# Technical BULLETIN

2007: PZ50GT (8GK), PZ50FX (8GN), PZ50M (8GP), PZ50VT (8GJ)  
2008: PZ50 (8GC), PZ50GT (8GK), PZ50RT (8GN), PZ50MT (8GP), PZ50VT (8GJ)  
2009: PZ50 (8GC), PZ50GT (8GK), PZ50RT (8GN), PZ50MT (8GP), PZ50VT (8GJ)  
Ground Failure at Joint Connector

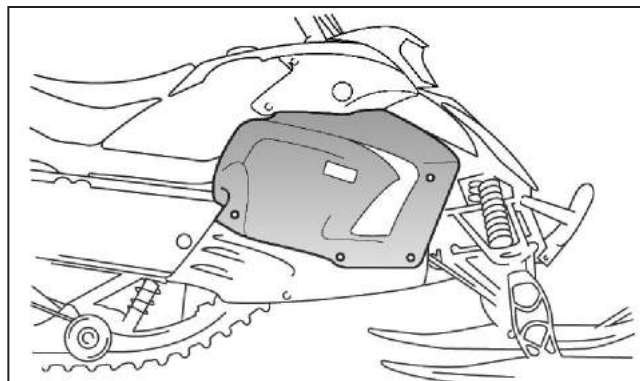
If you encounter an unfamiliar unit and you are unsure if the unit has been modified, check for the sub-harness translucent 6-pin connector. If the 6-pin connector is installed, the unit has been modified.

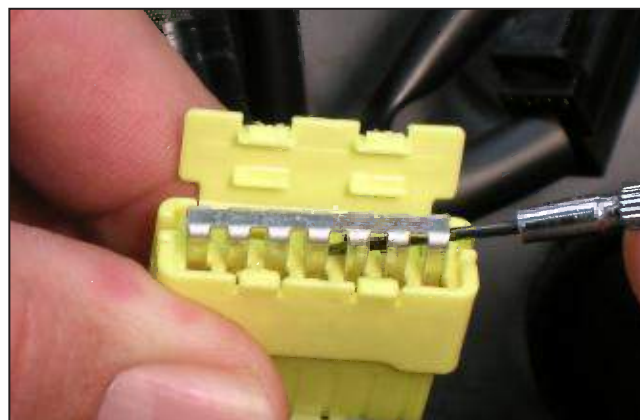
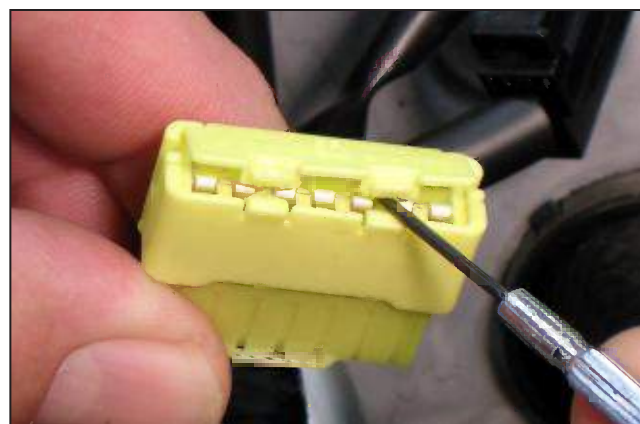
2. Remove the vinyl tape from the 14-pin yellow bus bar connector.
3. Inspect the existing yellow connector and terminals:
  - Unlock the top cover of the yellow connector by using a small screwdriver or equivalent to pry the two tabs.
  - Remove the metal bus bar by prying each end of the bar and lifting the bar out.
  - Closely inspect the inside and outside of the yellow connector for heat related damage.

**If no damage to the connector, proceed to step 4.**

**If the connector is damaged but can still be disassembled and no more than one wire is damaged by heat, proceed to step 7.**

**If two or more ground wires are damaged or if the yellow connector is damaged to the point where disassembly is not possible, contact your RTA for further instructions.**

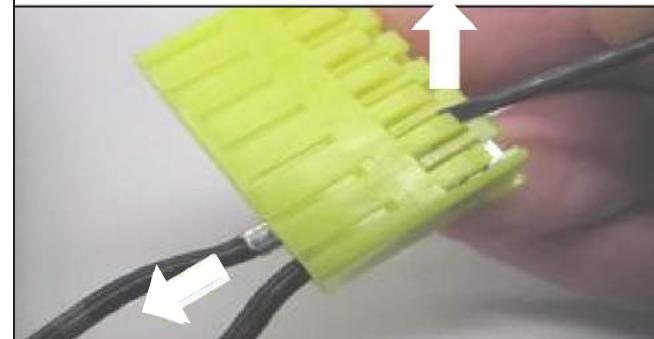
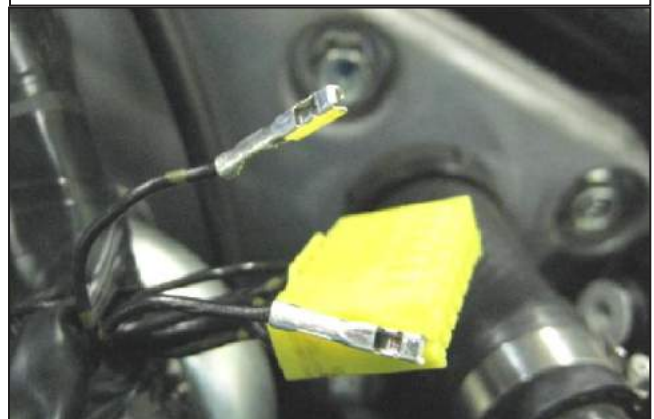
- If there is no heat damage, remove the top cover of the existing yellow connector by prying the sides of the cover out and up.

- Remove wires #5 and 6 from the existing yellow connector:
  - Pry the locking tab out from the terminal.
  - Pull the wire and terminal out of the yellow connector.

- Remove the two wires from the new yellow connector supplied in the kit and install them in the now empty slots #5 and 6 of the existing yellow connector on the unit. Proceed to step 9.

- If only the yellow connector is damaged by heat, remove each wire from the original connector and reinstall each one to the same location on the new yellow connector supplied in the kit, except for wires #5 and 6 which will be moved to the translucent 6-pin connector in step 9.

- If there is no wire damage, move wire #7 from the existing yellow connector to slot #5 in the new yellow connector.

REMOVE TOP COVER.

LIFT UP YELLOW TAB AND PULL WIRE OUT.

MOVE WIRES #5 AND #6 TO 6-PIN CONNECTOR.

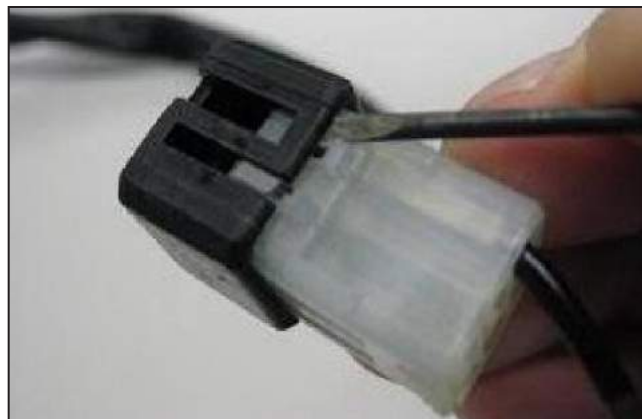
9. Connect the wires from #5 and 6 to the translucent 6-pin bus-bar connector:

- Remove the translucent connector black cap.

- Remove the 6-pin bus bar.

- Insert ground wires #5 and 6 from the unit's main harness next to the existing wire in the 6-pin connector.

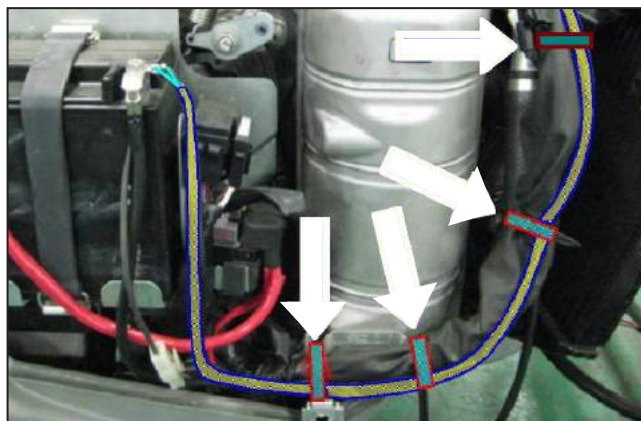
Ensure both connectors are positioned with the wires pointed down, then tape the sides and the top of the connectors (see adjacent photo).

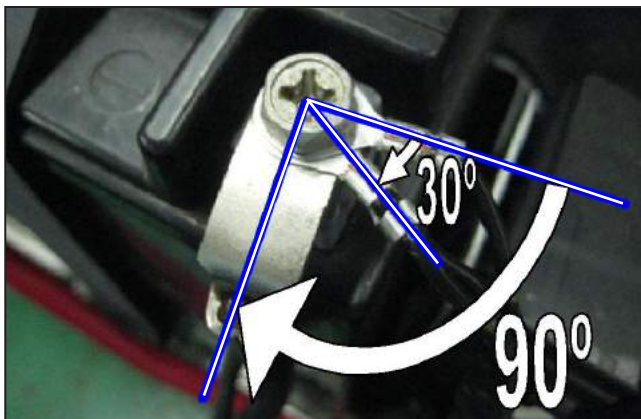
14. Connect the two eyelet connectors to the negative battery terminal as illustrated.

Make sure the wires are positioned on the negative battery terminal as shown in the adjacent photo to ensure a good ground.
